IN THE MATTER Submissions relating to Plan Change 11

EVIDENCE OF JEANETTE ALICE WARD

APPENDIX 1 - Indicative plans for alignment of the spine road in the vicinity of Pineglades

APPENDIX 2 - Indicative design plans for the shared paths, shared accessways, Fairhurst Place and Jozecom Place

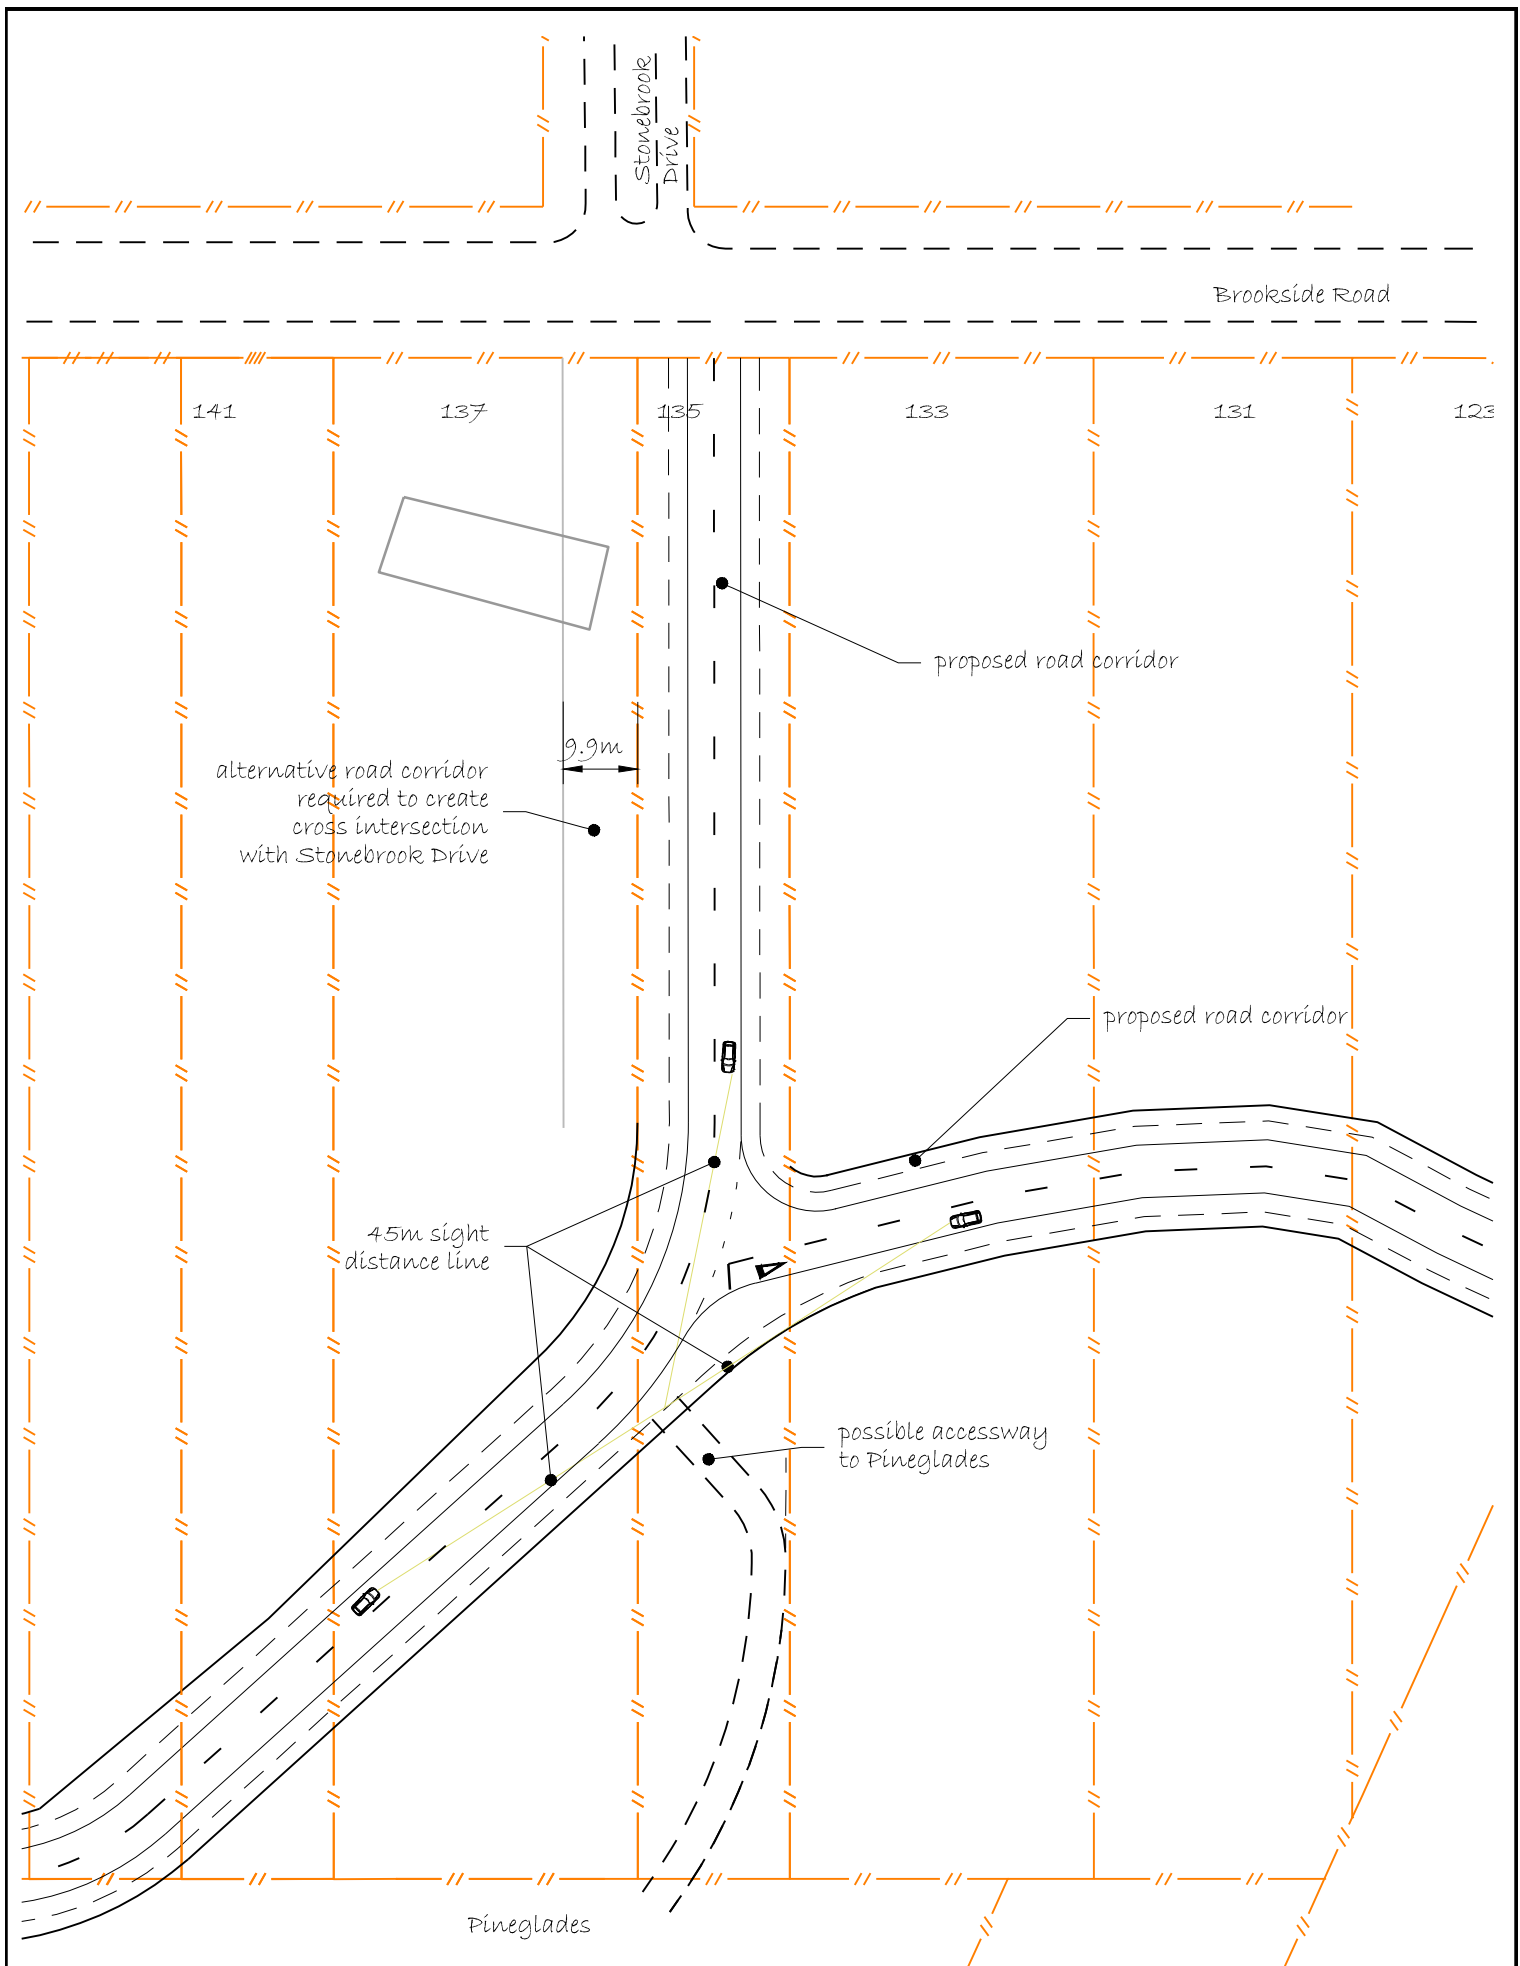
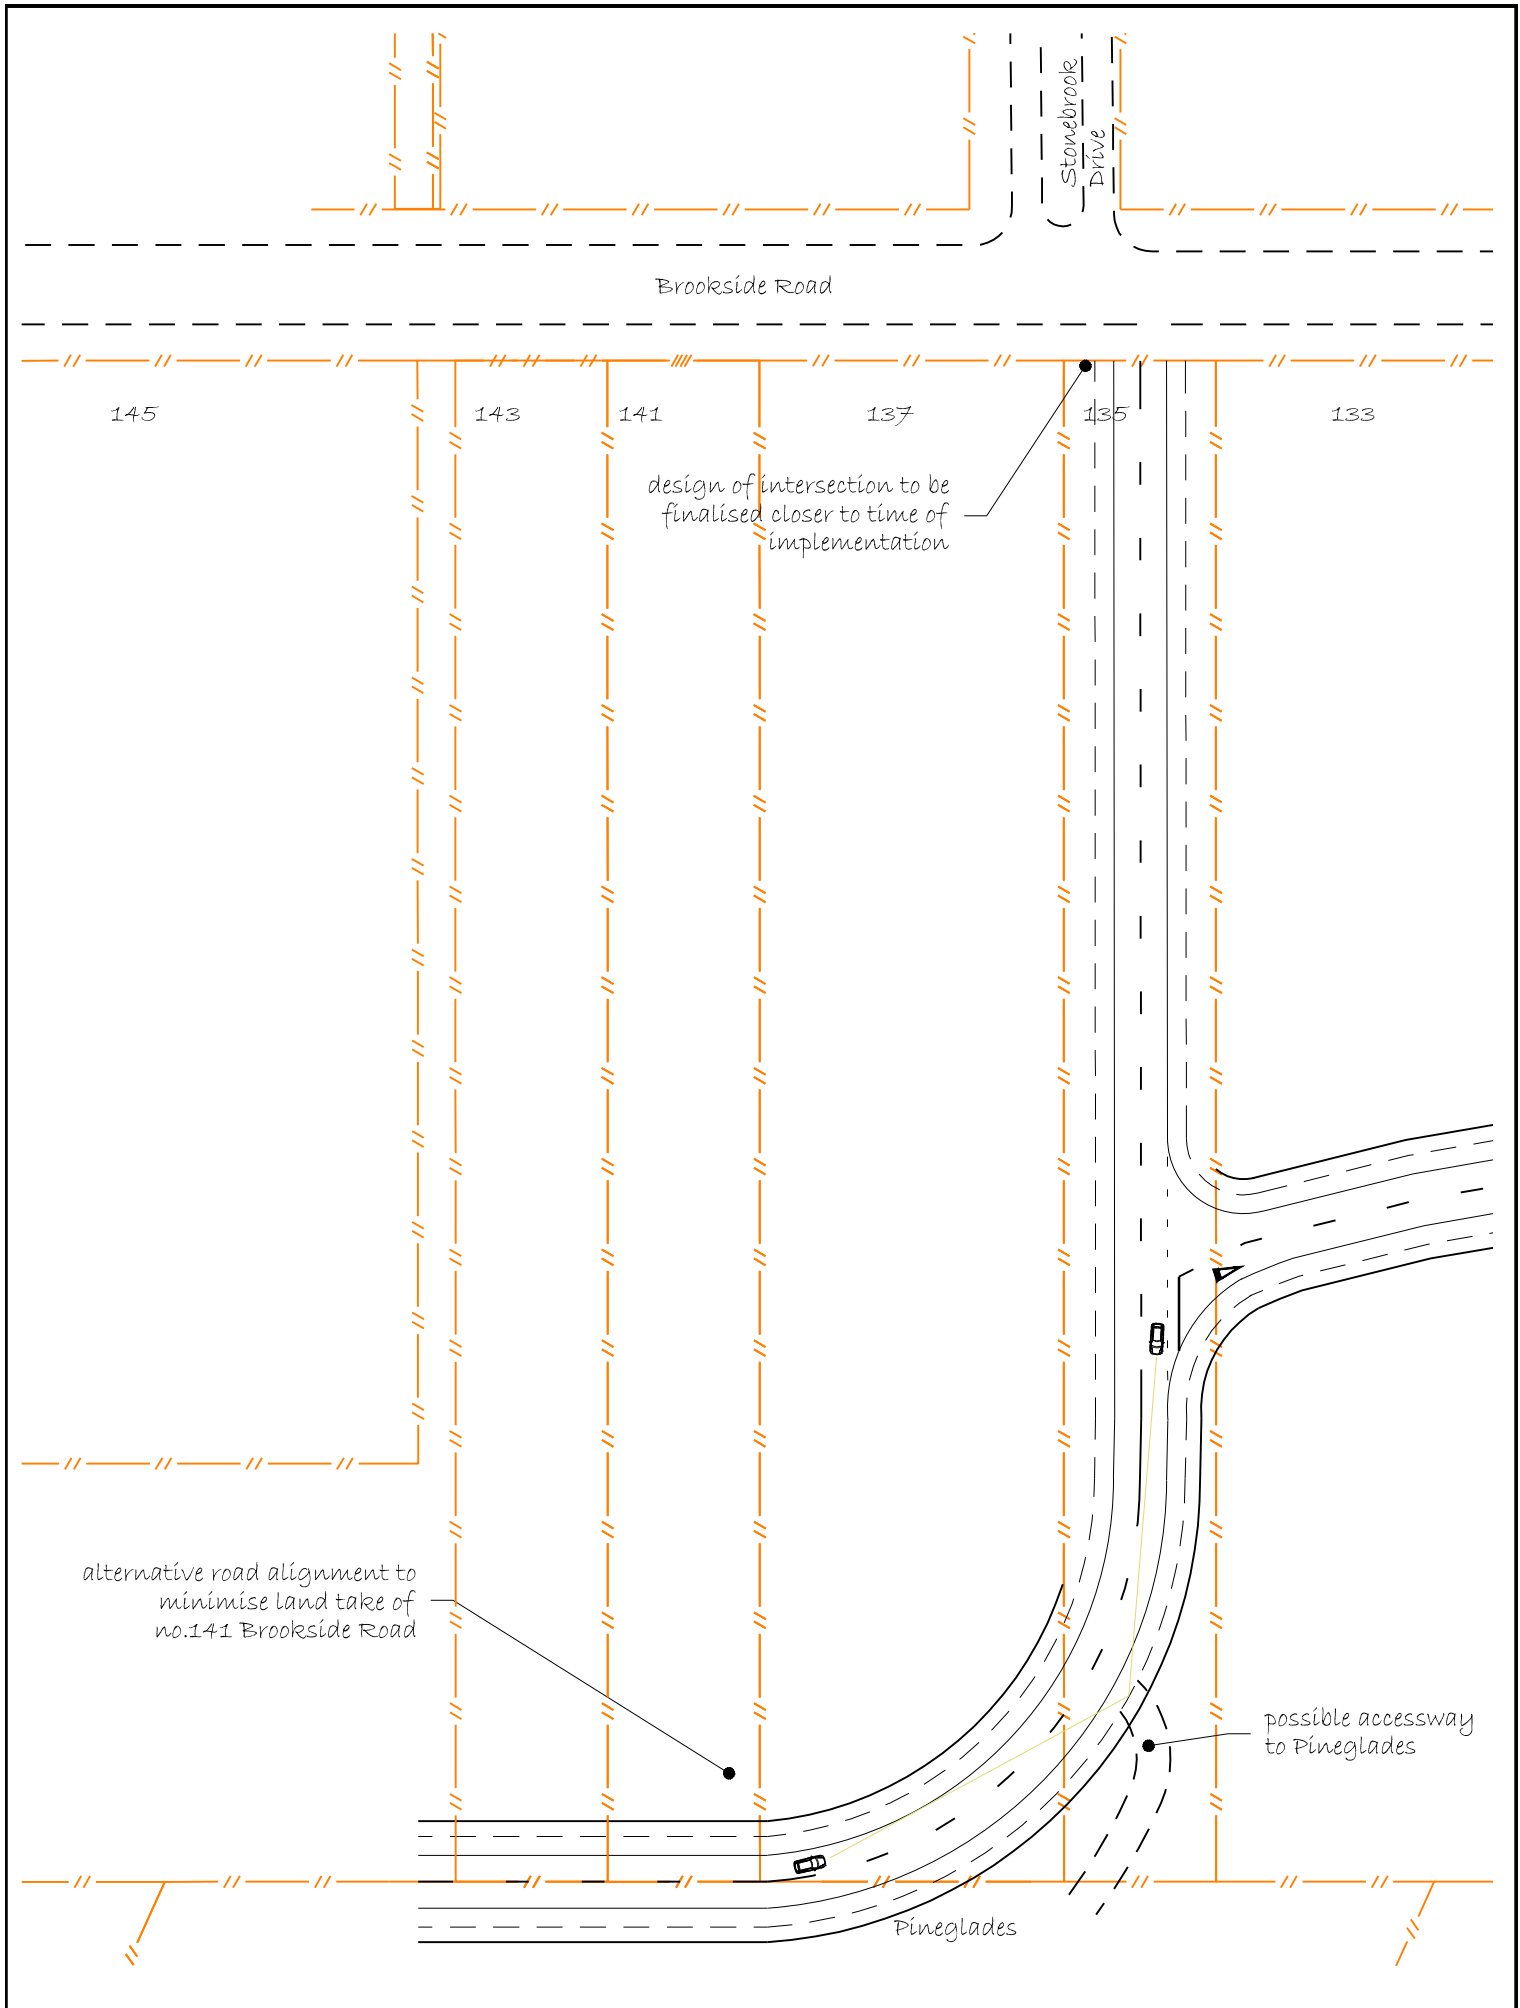
48. The new spine road intersects with the access to the Pineglades Naturist Club and requires that access is now onto the spine road instead of Brookside Road. A submission has been received with respect to the safe layout of the new access point.
49. The provision of any access onto a public road requires compliance with a number of safety rules (sight distance and separation distance) outlined in the District Plan. In this situation where the access is to a local road with a speed limit of 50km/h, in a Living Zone, a sight distance of 45 m is

required by the Plan. The minimum required separation from an adjacent intersection is 10 m.

50. An indicative layout of the access, depending the final alignment of the spine road, is shown in Appendix 1, sheets 1 and 2. Both spine alignments indicate that the access can be built in such a way that meets the new road at right angles and can achieve the required sight distances and separation distances. The spine road option on sheet 2 improves sight distances and increases the separation distance.
51. The presence of the new road linking the spine road to Brookside Road does add another movement that users of the access will need to be aware of however this is not considered to be onerous on users of the access.

Shared path concept

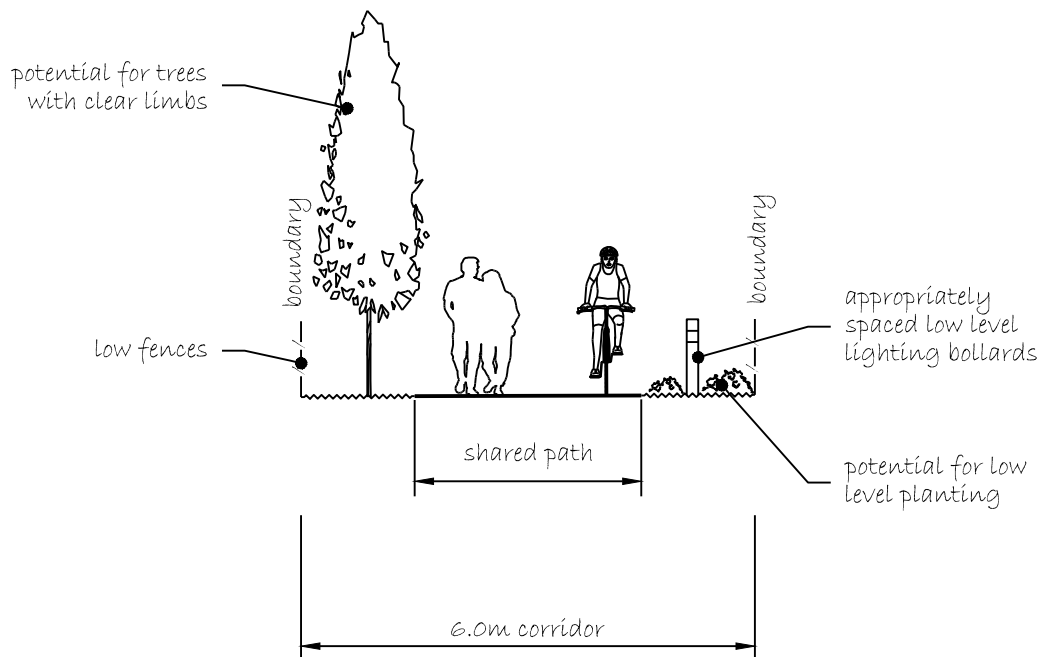
28. There is limited guidance on the shared path ‘corridor’ widths but it is generally accepted that the width is related to length, i.e. as the link lengthens the width needs to increase, up to a maximum of course. The width of the Rolleston walkway/cycleway corridors has been determined by the Council to be a minimum of 6 m as part of the Structure Plan process. This is considered acceptable for the lengths of paths shown on the Structure Plan Map, however if lengths were increased significantly the width would need to be reviewed. For example I understand the Council are considering shortening the new southern cul de sac off Fairhurst Place, this will increase the length of proposed walkway/cycleway that links with Jozecom Place from 150 to 200 m, in this instance I would recommend the corridor be widened to 10 m. Likewise for the indicative proposed link off East Maddisons which creates a section of walkway/cycleway over 200 m long, a width of 10 m would be more appropriate.

29. The design within the walkways/cycleway corridor is critical to its success, by this I mean that locals feel it is safe to use and that there is limited opportunity for anti-social behaviour and crime. There are a number of design tools that can be used to help achieve this and these are related to the major principle of ‘Crime Prevention through Environmental Design’ (CPTED) which is “Natural Surveillance – see and be seen”. People are usually less likely to act antisocially or commit crime if they are (or think they are) being watched, conversely people are likely to feel safer if they think someone is looking out for them. However

32. Appendix 2, Sheet 1, illustrates the likely cross section of a walkway/cycleway corridor.

Shared accessway concept
motor vehicles separated from pedestrians and cyclists
no parking available

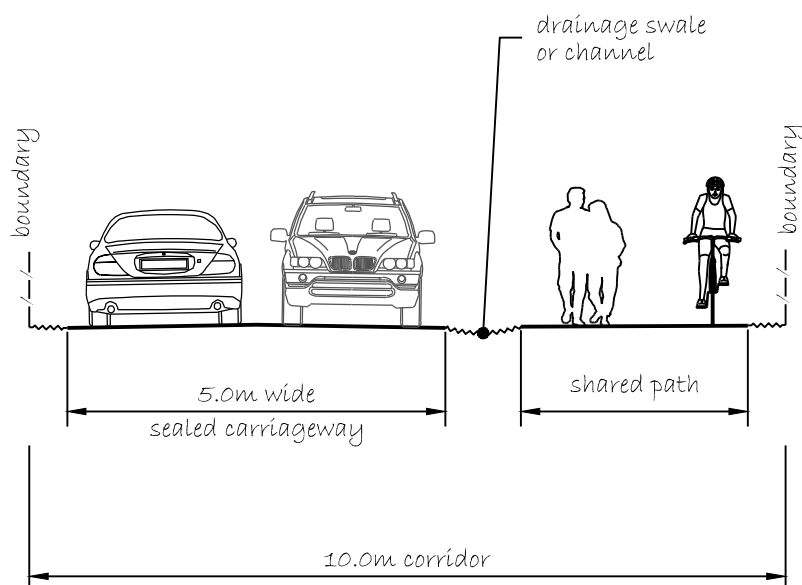
43. The extension of Jozecom Place commences from the northern corner of the existing cul de sac and extends approximately 150m to the east terminating with a 11 m radius cul de sac head. The alignment would create an interesting meander in the road. The south side of the exiting cul de sac provides the opportunity for the creation of landscaping areas if the Council retains this land as road reserve. Submitters have asked what the extension would look like, an indicative plan is shown in Appendix 2, sheet 4.
44. The cross section of the extension would be the same as that discussed in paragraph 42.
45. To facilitate access to properties in future if the land was subdivided an indicative plan show how each lot could be accessed. This scenario

requires the use of two short shared accessways so that the walkway/cycleways can be accessed. The general arrangement of these shared accessways would include a 5 m wide vehicle access lane and a shared path within a 10 m corridor. An indicative cross section of the shared accessway is shown in Appendix 2, sheet 1. The vehicle access part of the accessway would be private and the path area owned and maintained by Council. It is anticipated that the corridor would be open and spacious however a low fence could be used to separate the two areas.

Indicative design of Fairhurst Place with low profile kerb
(alternatively a swale could be provided in the berm for stormwater management)

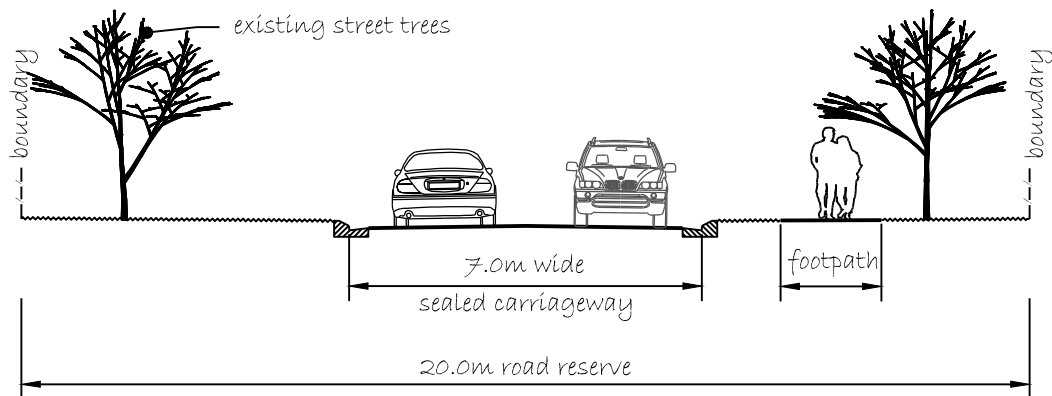
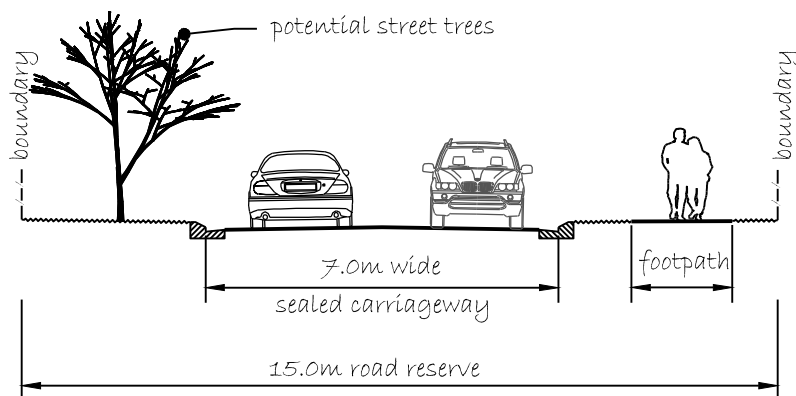
41. Fairhurst Place and Jozecom Place are currently built to a rural local road standard with seal widths of 6.7 and 6.3 m, respectively. There is no kerb and channel and no footpaths. Fairhurst Place has a standard road reserve width of 20 m which allows space for the street to be upgraded to a more urban standard in the future. Jozecom Place however has a road reserve width of 12 m and would require widening in the future to facilitate an upgrade, a width of between 15 m and 20 m would be required as per the 'neighbourhood street' concept in the SDC Subdivision Design Guide.

42. Submitters have asked what form these upgrades may take. Appendix 2, sheet 2 shows an indicative design cross section for each street. The upgraded streets would be 7m wide with either low profile kerb (as used elsewhere in Rolleston) or grass swales. A footpath on at least one side of the road would be required. The Fairhurst Place design incorporates the existing street trees which are feature of the street, and depending on the extent of the Jozecom Place widening, one side of the street could include street trees.

Indicative design of new roads off Fairhurst Place

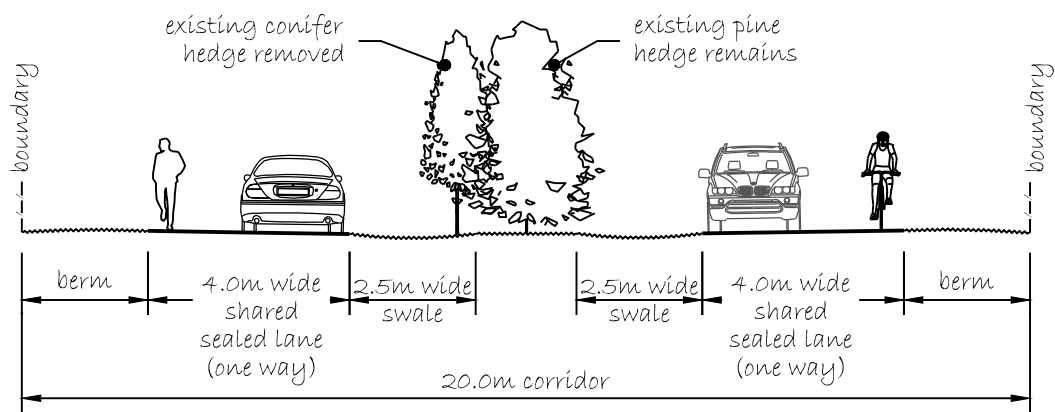
33. The structure plan includes two new cul de sacs off Fairhurst Place. As mentioned above I understand these roads are to provide access to properties and to the walkways/cycleways at the end of the roads. Currently there are radiata hedges and conifers in the 20 m corridor. Submitters have asked what form these new roads are likely to take and that the existing radiata hedges remain.

35. The radiata hedges are located centrally and the conifers off set. Some submitters have requested that the hedges remain in place. A concept design has been prepared that retains the radiata hedge but requires removal of the conifers. See Appendix 2 – Sheet 3.

36. The arrangement of the road requires a 4 m wide one way lane each side of the hedge, these are to be shared by vehicles, cyclists and pedestrians. Alternatively there is space for footpaths alongside the lanes if separation is required. The lanes do not require kerbs as a swale could be accommodated; this will help retain the semi- rural feel of the area. Northwood Boulevard in Christchurch, although a through road, has a similar design where trees from an existing poplar shelter belt have been retained.

37. At the end of the road the lanes will be linked by a 5 m wide turn which can accommodate the turning movements of vehicles up to a 90% two axle truck (about 8 m long). Larger vehicles would be required to make a three point turn, however most local streets do not provide for these situations given the low occurrence and focus on residential access.
